MODIFICATION TO SSD 5249-2012

This application has been prepared by Ethos Urban on behalf of Lawson Square Pty Ltd, pursuant to section 4.55(1A) of the *Environmental Planning and Assessment Act, 1979* (EP&A Act) to modify Development Consent SSD 5249-2012 relating to 1 Lawson Square, Redfern (the site).

Figure 1: Proposed typical Tower 1 commercial level

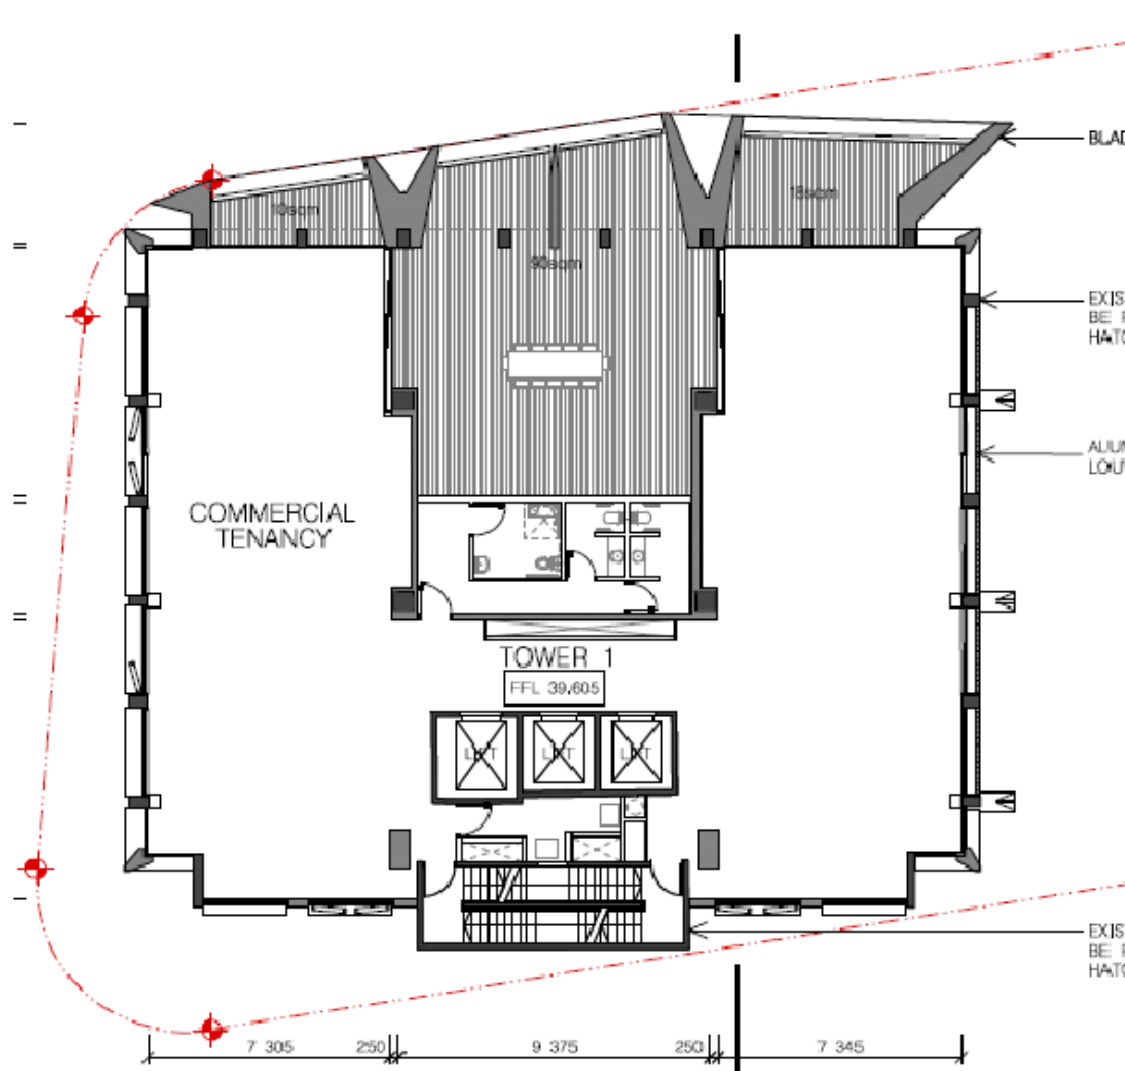
It is proposed to provide large centrally located north facing balconies on the commercial floors on Levels 1 to 5 on Tower 1. To achieve this the glass line has been setback in the central portion of the façade on Levels 1 to 5 on Tower 1 (refer **Figure 1** below).
